Pre-Occupancy Fire Risk Assessment

Date 13th September 2022

Marjon Studio School

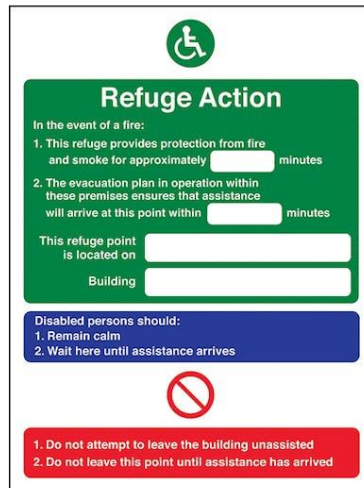
Issue 3. Sign as shown below should be mounted on top of all stairways and stairway levels
